## **ADDENDUM-1**

**Dust Suppression and Water Systems Package for Singrauli STPP Stage-III (2x800 MW)**

**Tender Ref: 77/24/6170/BPA**

**Pre-Bid Clarification-01 dtd 14.03.2025**

**ELECTRICAL EQUIPMENT LAYOUT  
FOR **CHP MCC-1** NEAR TP-19**

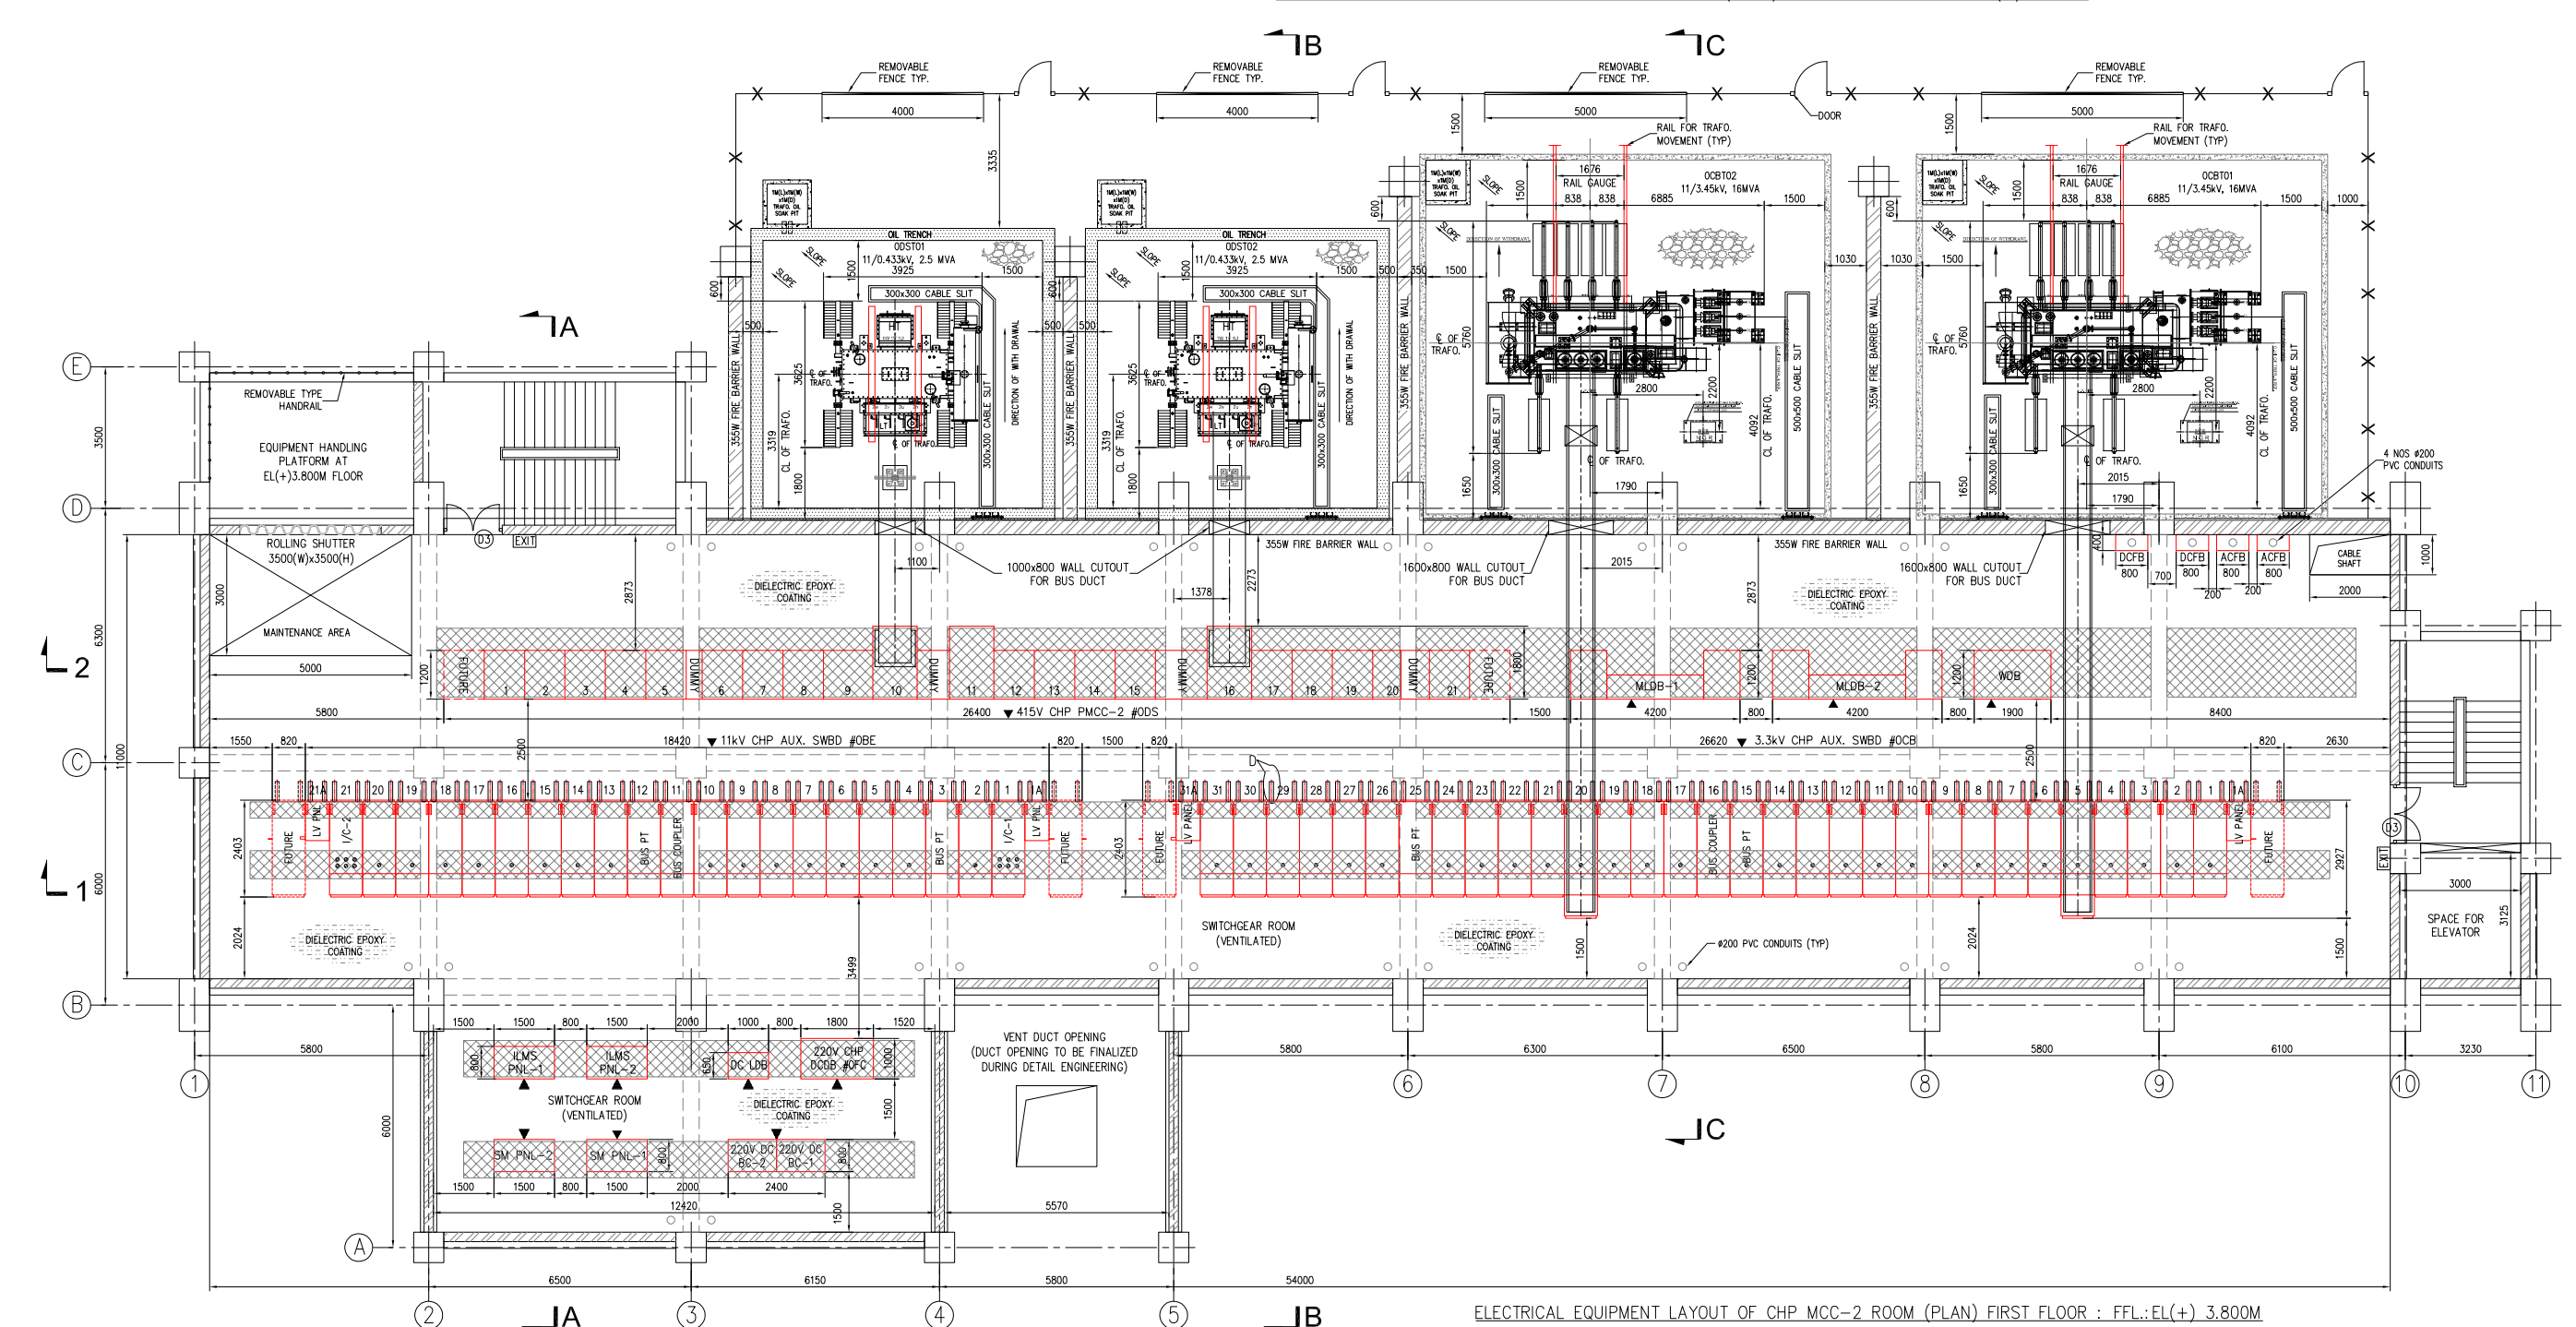
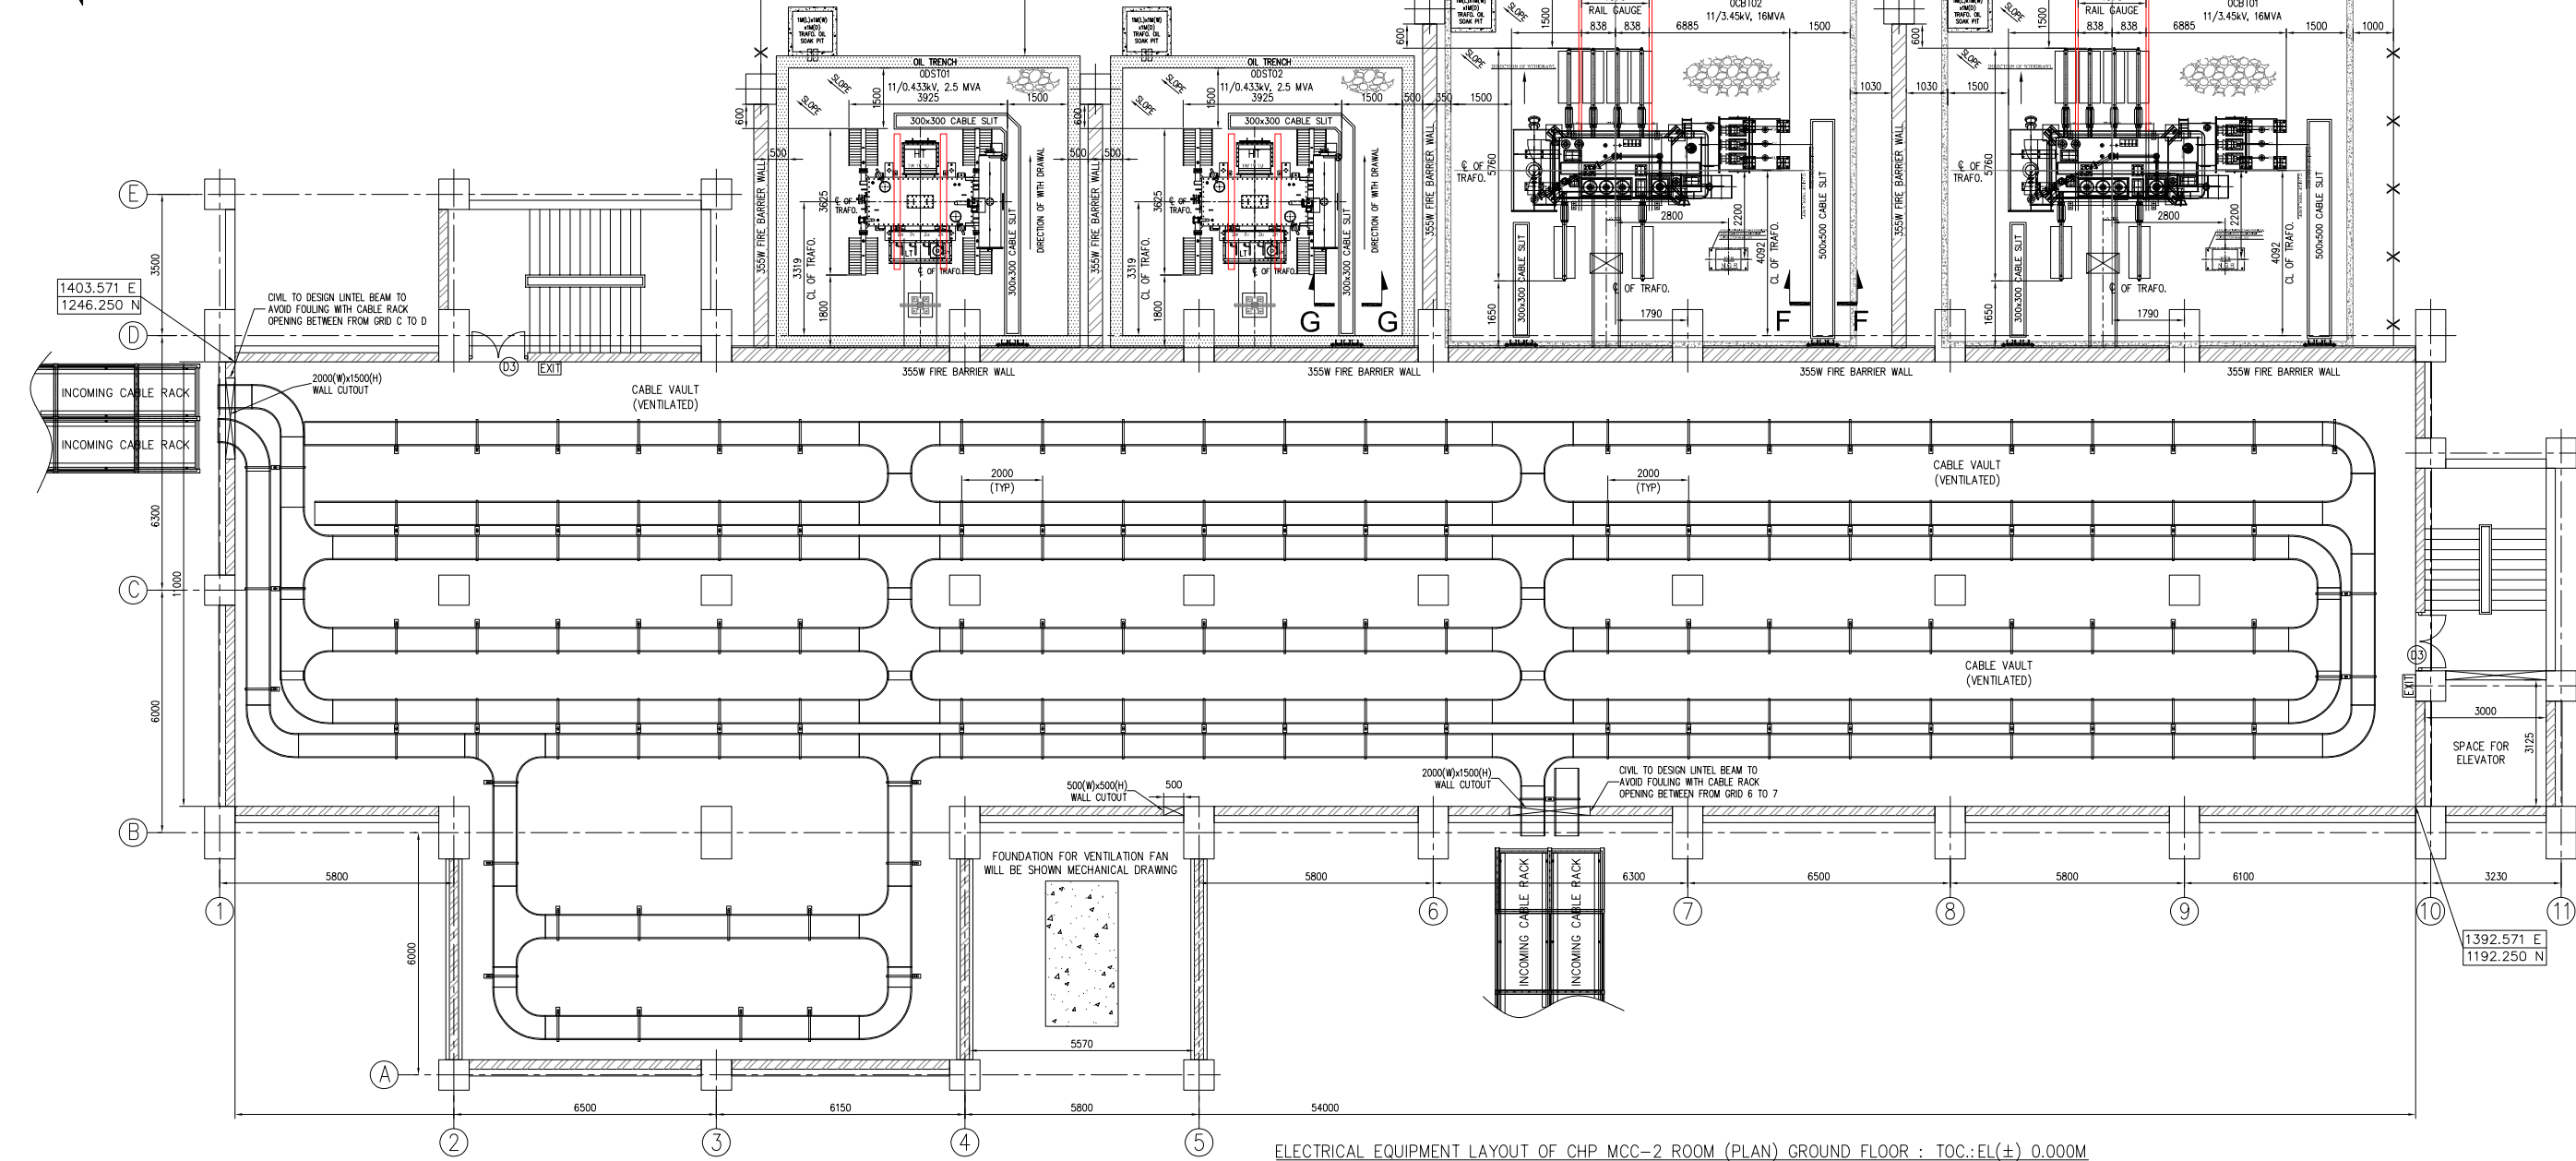
Sl. No.	Area	Skirt board height in mm	Skirt length ahead of front end of chute	Skirt length behind of rear end of chute	1	CHP conveyors	750	3000	500	2	Belt feeders	1000	3000	500	Please note for proper dust suppression we require at least 3.5 times of belt width ahead of front end of chute. <b>Kindly confirm the availability of the same.</b>	Any additional skirt length if required by bidder for proper dust suppression shall be under this package bidder's scope (design, supply, erection etc. including the interconnection with the existing skirt board already provided by conveyor package vendor of BHEL).
Sl. No.	Area	Skirt board height in mm	Skirt length ahead of front end of chute	Skirt length behind of rear end of chute																	
1	CHP conveyors	750	3000	500																	
2	Belt feeders	1000	3000	500																	
14	Technical enquiry specification for Dust Suppression & Water Package of Coal, Biomass, Limestone & Gypsum Handling System – Document No.IS-1-23-2008/DS	06.24.00	33 of 47	Specifically, for DFDS/ cold fog system, make of nozzles considered by bidder shall be from an NTPC approved source. In case, make of nozzles proposed/ considered by bidder is rejected by NTPC, then bidder has to go ahead with other NTPC approved source for nozzles, without any commercial implication.	Make of nozzles is not available in the approved make list. As we are the system provider, we shall provide nozzles as per make previously supplied in NTPC project. <b>Please confirm.</b>	Refer indicative vendor list, BOIs for DFDSS shall be from NTPC approved sources.															
15	Annexure – 8 – Piping SLD tender purpose.	-	1 of 1	SWS / DWS shall be provided MCC / Control rooms/ toilets / etc.	<b>Kindly provide GAD / details with no of floors of all other buildings applicable for SWS and DWS System</b>	MCC GA drawings attached
